11 November 2020

Response to Submissions SSD-9835-MOD 2 Sydney Football Stadium – Fitness Facilities

Figure 1 Comparison of exhibited (top) and proposed (bottom) detailing as viewed from Driver Avenue

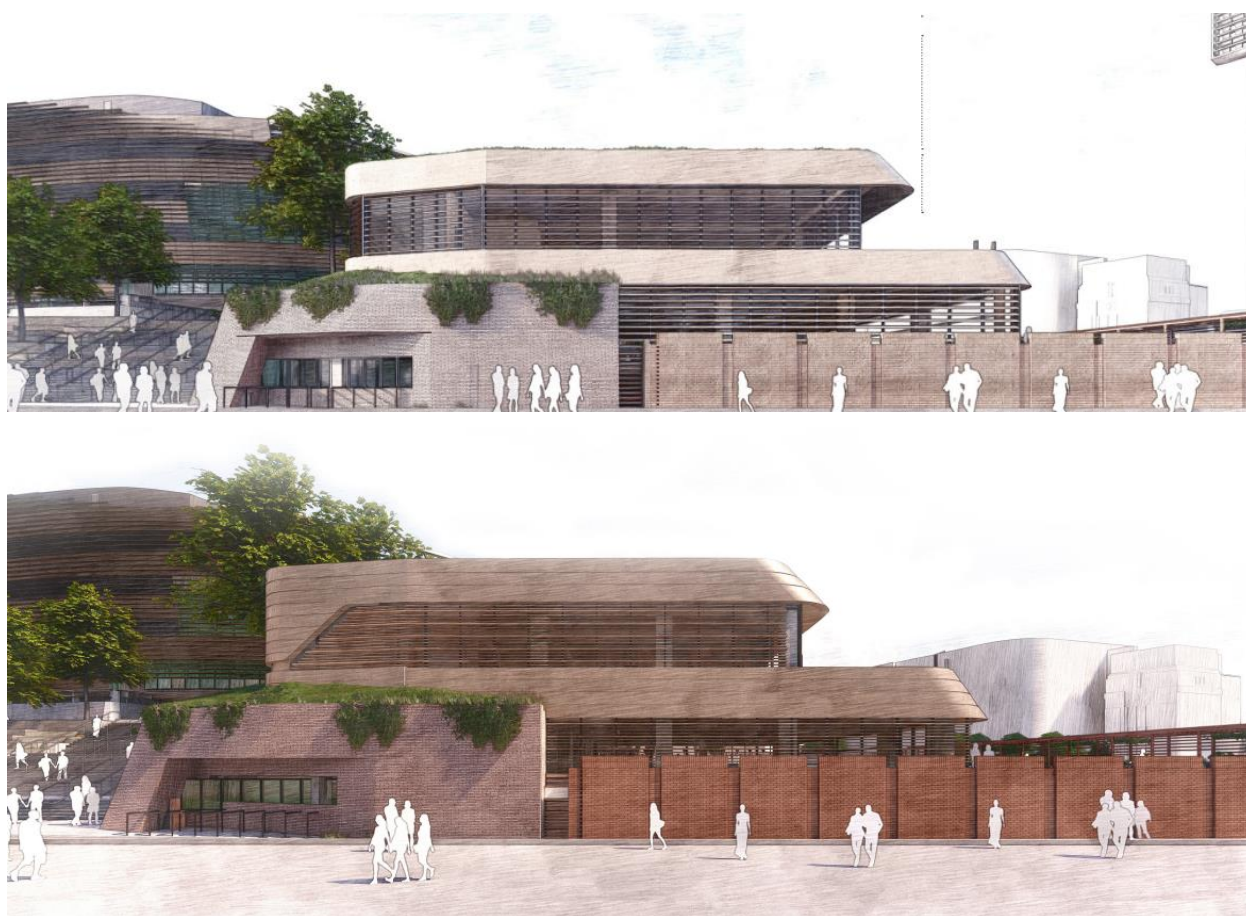
- Refining the building façade to take into account alterations to the plant room and mechanical louvre sizes and the balustrade to the fitness terrace, while retaining the sculptural ribbon detailing.

- Refining the footprint of the upper level of the building so that it provides full solar and weather coverage by replacing the pergola louvres to a metal deck roof construction, which also provides for zones for photovoltaic cells (discussed further below).
